Access Compliance Report

Public Rights-of-Way

(Curb Ramps)

Intersection ID: 20116	Main Street: BARCLAY_DOWNS_DR	Cross Street: BULFINCH_RD	Location: NE
ADA ID: F44DF18AB177	Ramp Type: BlendTrans1	Initial Pass/Fail: Fail	Overall Compliance: No
			Severity Score: 21.25

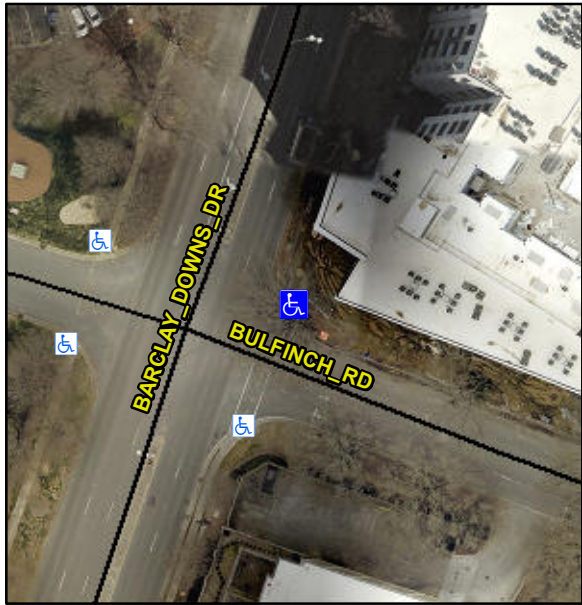
Codes/Mitigation Info/Possible Solution			Field Measurements/Component Compliance					
	Possible Solutions:		Compliance	Description	Data	Compliance	Description	Data
	Remove & Replace Curb Ramp With Two New Directional Ramps or Equivalent.		N/A	Ramp Length (in)	65.5	Yes	BlendTrans Slope (%)	3.8
			No	Ramp Width (in)	47.0	No	BlendTrans XSlope (%)	5.1
			N/A	Flare Type LT	N/A	N/A	Flare Type RT	N/A
			N/A	Flare Slope LT (%)	N/A	N/A	Flare Slope RT (%)	N/A
			N/A	Flare Traversable LT?	N/A	N/A	Flare Traversable RT?	N/A
			N/A	Landing Length (in)	N/A	N/A	DWS Provided?	N/A
			N/A	Landing Width (in)	N/A	N/A	DWS Contrast?	N/A
			N/A	Landing Slope (%)	N/A	N/A	DWS Length (in)	N/A
			N/A	Landing X Slope (%)	N/A	N/A	DWS Full Width?	N/A
Surveyor Notes:	N/A		N/A	Landing Curb? (Y/N)	N/A	N/A	DWS Offset (in)	N/A
			N/A	Shared Landing?	N/A			
	PROW/ADA:		N/A	Gutter Ponding?	N/A	N/A	Gutter Slope (%)	N/A
	Not Found, R304.5.1, R304.5.3		N/A	Gutter Lip Ht (in)	N/A	N/A	Gutter X Slope (%)	N/A

N/A	Painted X Walk1?	No	N/A	Painted X Walk2?	Yes
				X Walk 1 Direction	To W		X Walk 2 Direction	To S
				X Walk 1 Width (in)	N/A		X Walk 2 Width (in)	111.0
				X Walk 1 Slope (%)	0.7		X Walk 2 Slope (%)	3.6
				X Walk 1 X Slope (%)	4.0		X Walk 2 X Slope (%)	1.4
			N/A	Ramp inside XWalk1?	N/A	N/A	Ramp inside XWalk2?	Yes
			Road Slope (%)	2.0		Clear Space?	N/A	
			Road X Slope (%)	4.1	N/A	Clear Space to XWalk (in)	N/A	
		N/A	Any Obstructions?	N/A	N/A	Storm Grate/Utility Hazard?	N/A	
			Obstruction Type			Storm Grate/Utility Type		
					N/A			N/A
						Yes	Surface Condition? (G/P)	Good
						No	Curb Slope (%)	12.6
Total Cost:		\$ 3200.00
